BOARD OF COUNTY COMMISSIONERS
ORANGE COUNTY, FLORIDA

ADDENDUM NO. 3 / IFB NO. Y18-758-TA

SOUTH SERVICE AREA/EAST SERVICE AREA (SSA/ESA) 36-INCH POTABLE
WATER MAIN, 24-INCH RECLAIMED WATER MAIN AND J. LAWSON BLVD
POTABLE WATER RE-PUMP FACILITY

BID SET
 SCALE:
 DRAWING NO.: **D-102**
 SHEET: 185 OF 292

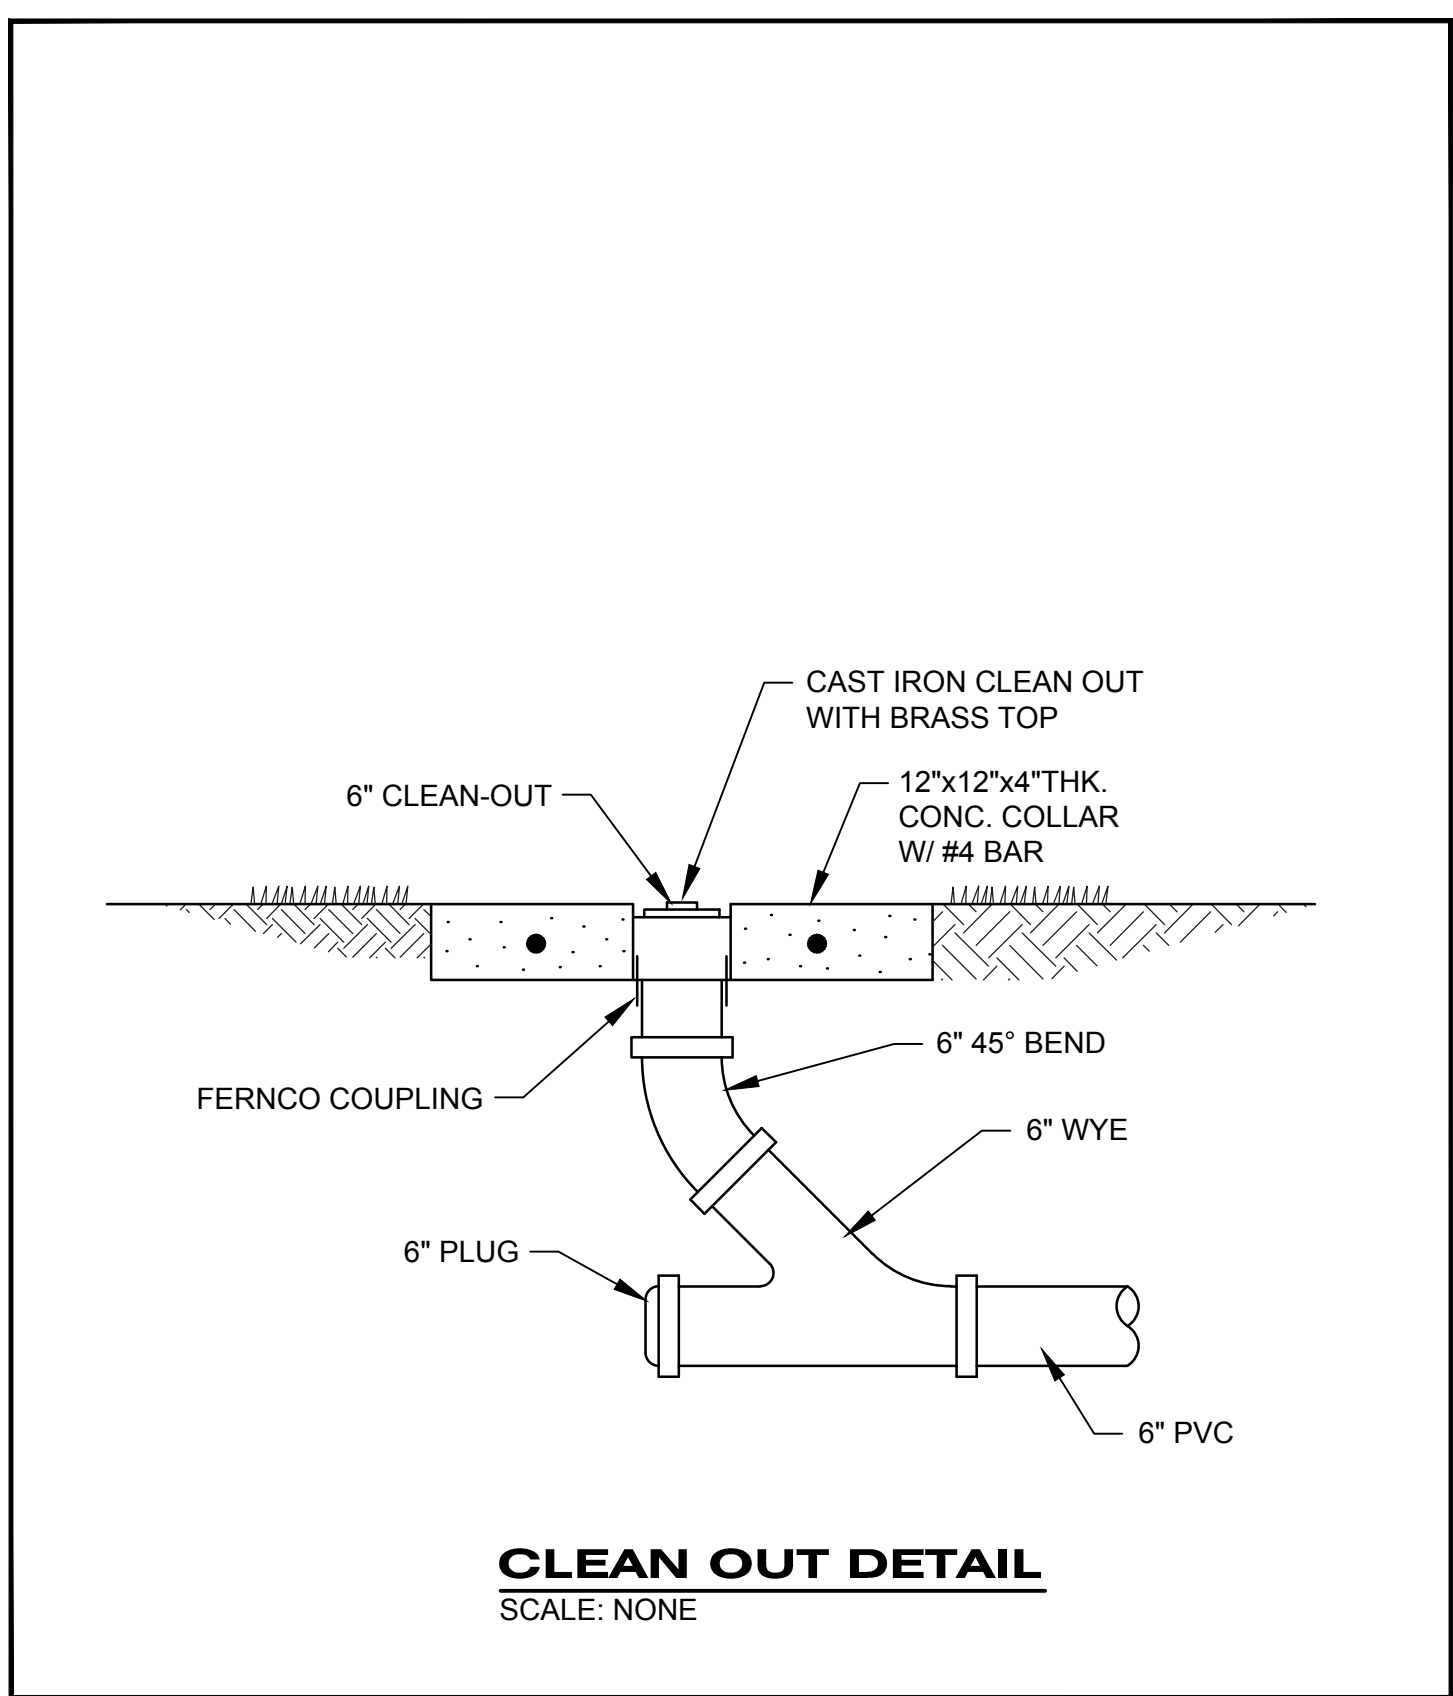
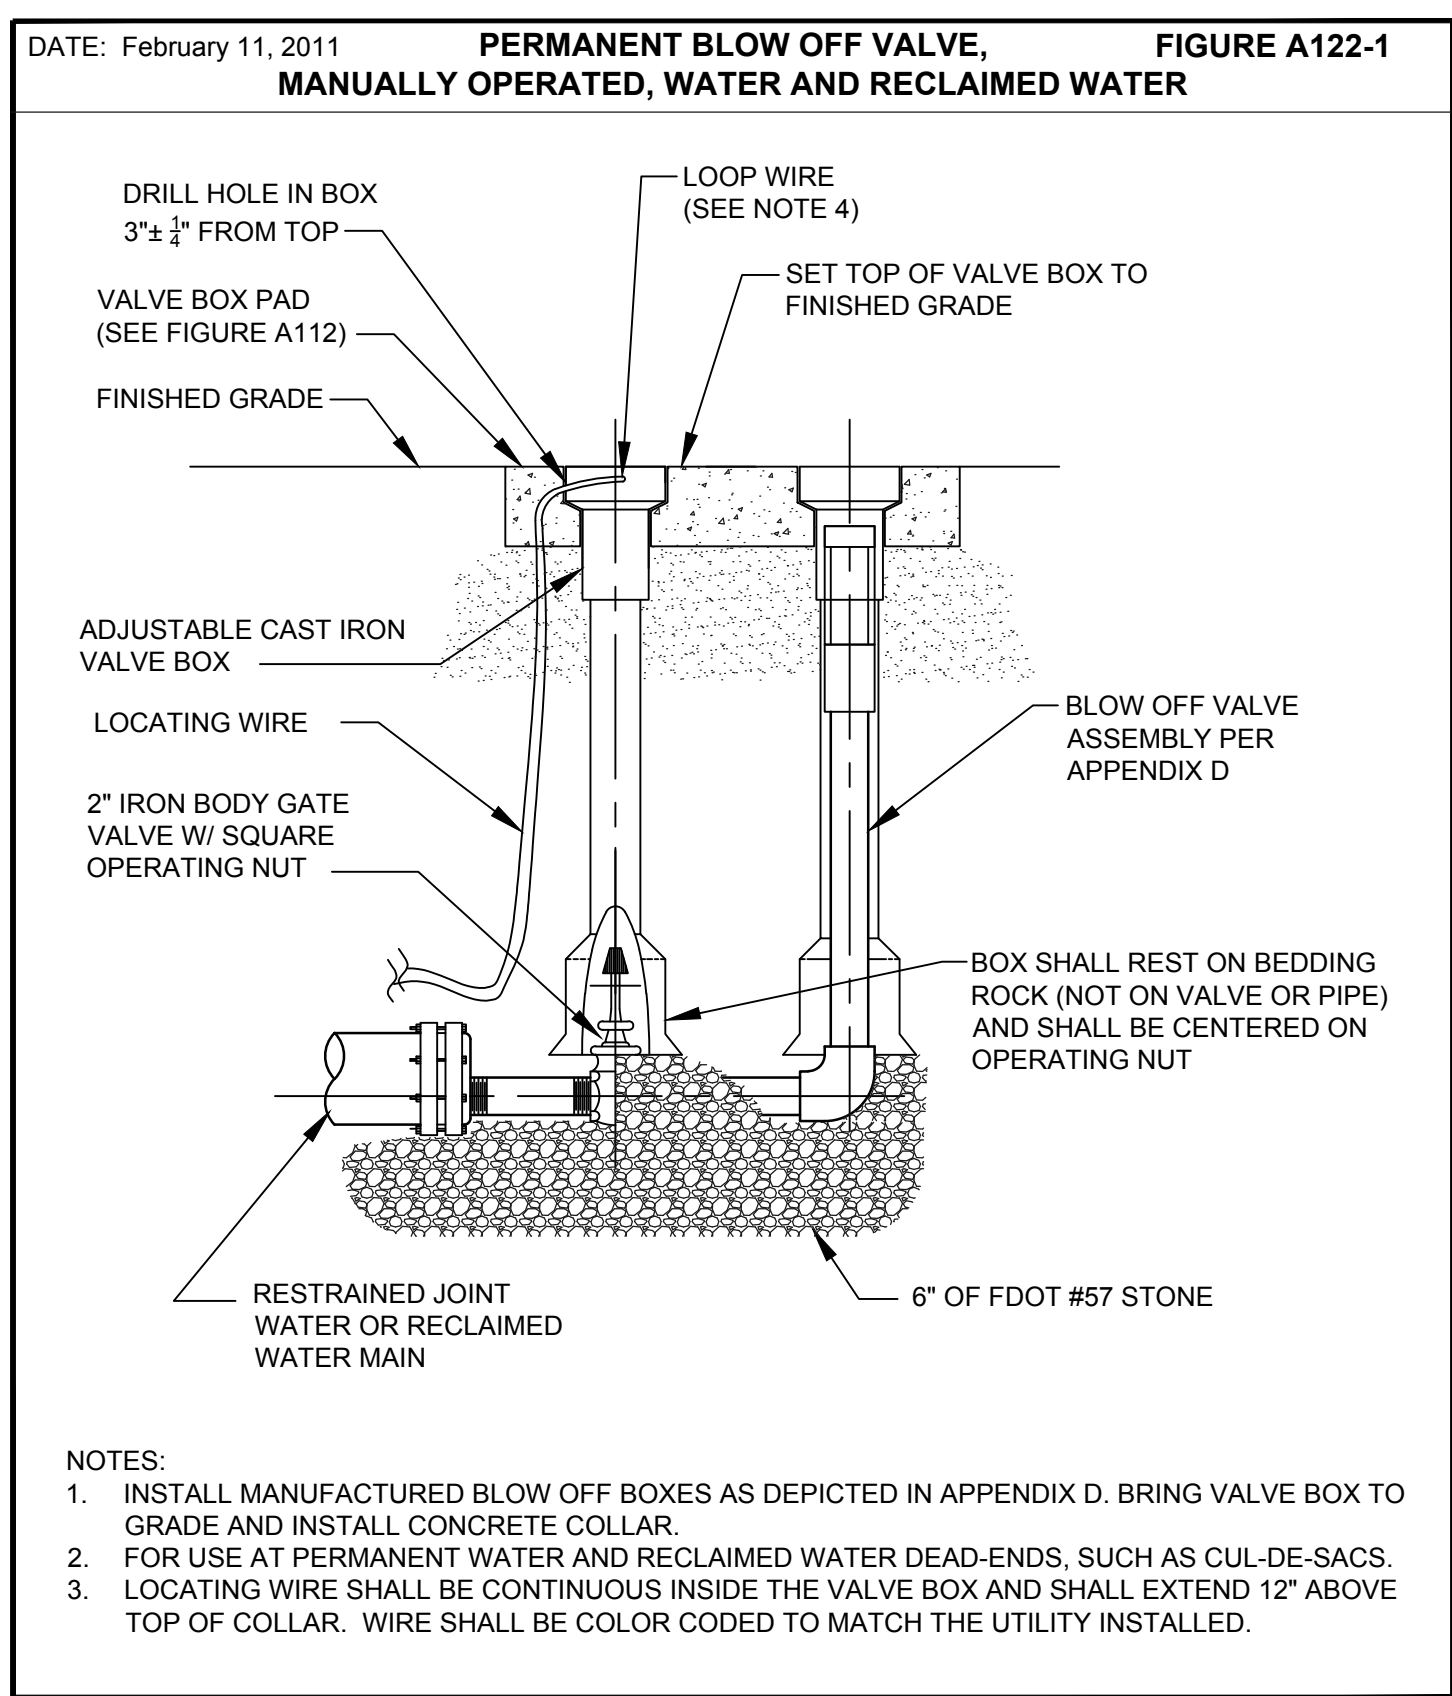
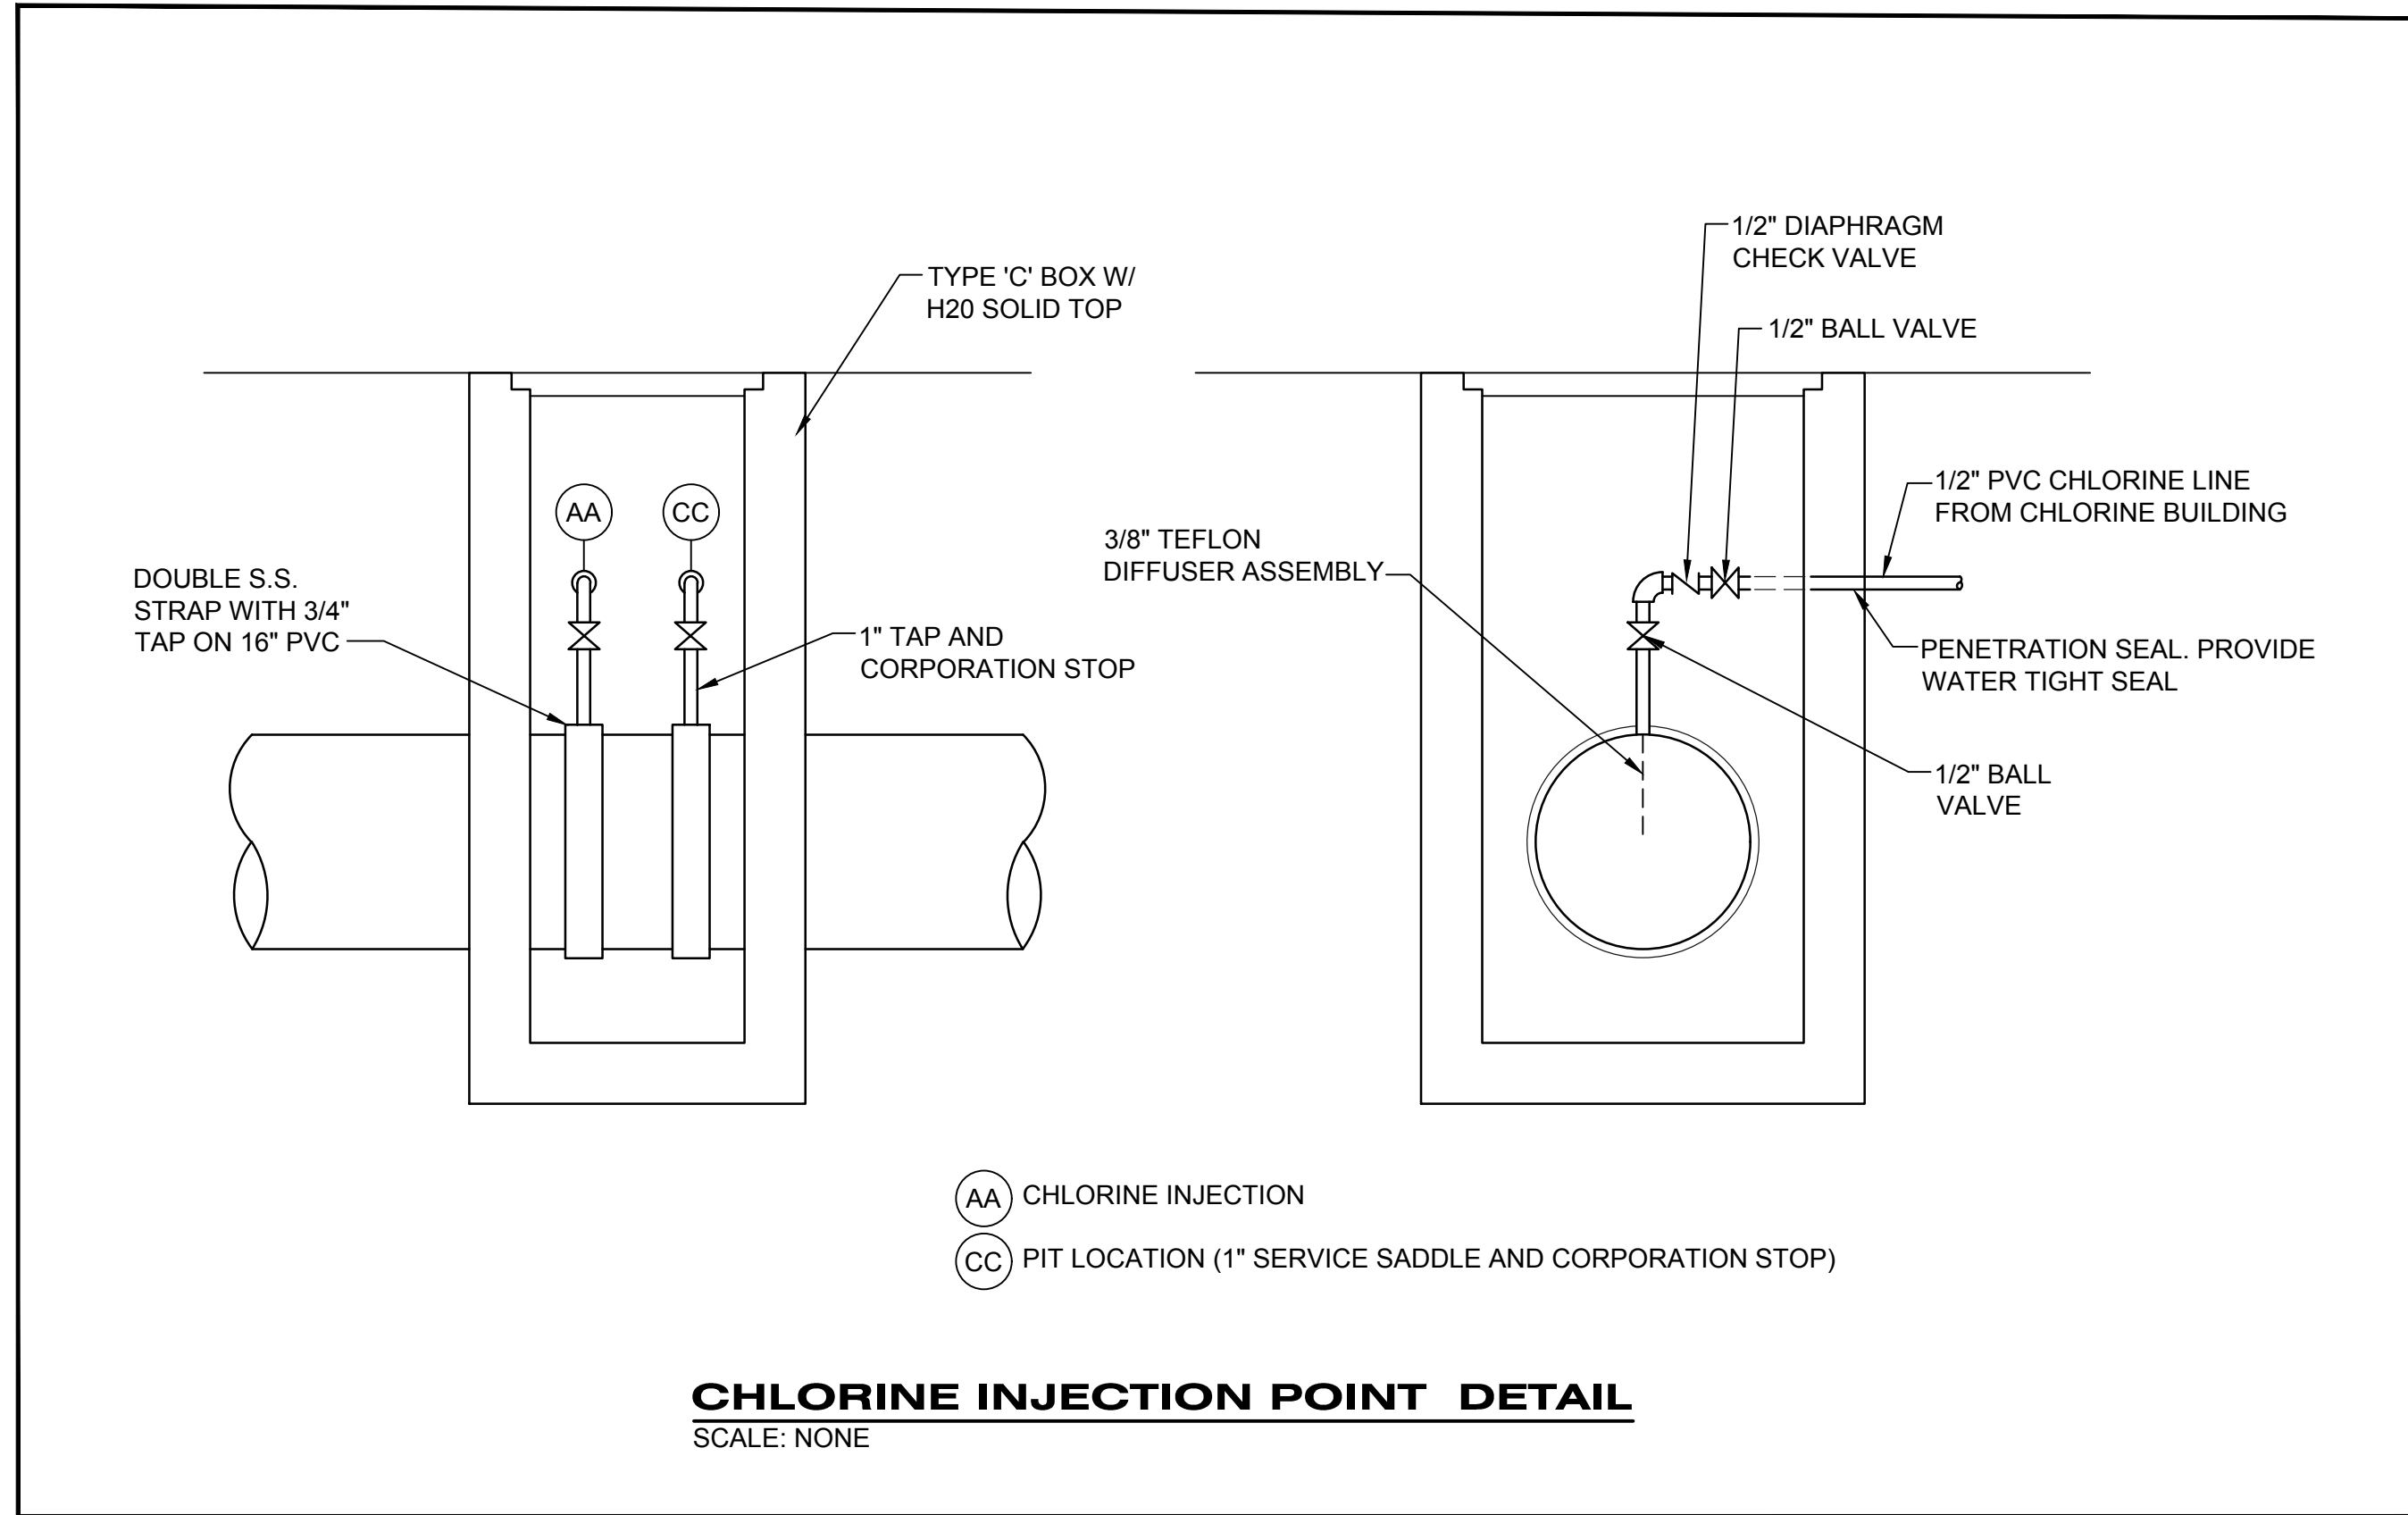
12. Q: Looking through the drawings and specifications, we are unable to locate any information concerning restraint limits. Are all lines to be restrained per Appendix D restrained the entire length of the line, per DIPRA or will an addendum be issued clarifying restraint limits? If we overlooked the restrain limits, can you point us in the right direction?

DRAWING D-102

A: See revised sheet D102, attached and labelled this addendum.

Amend: Delete drawing D-102 and replace with the revised drawing D-102. The revised drawing displays the restrained pipe table detail.
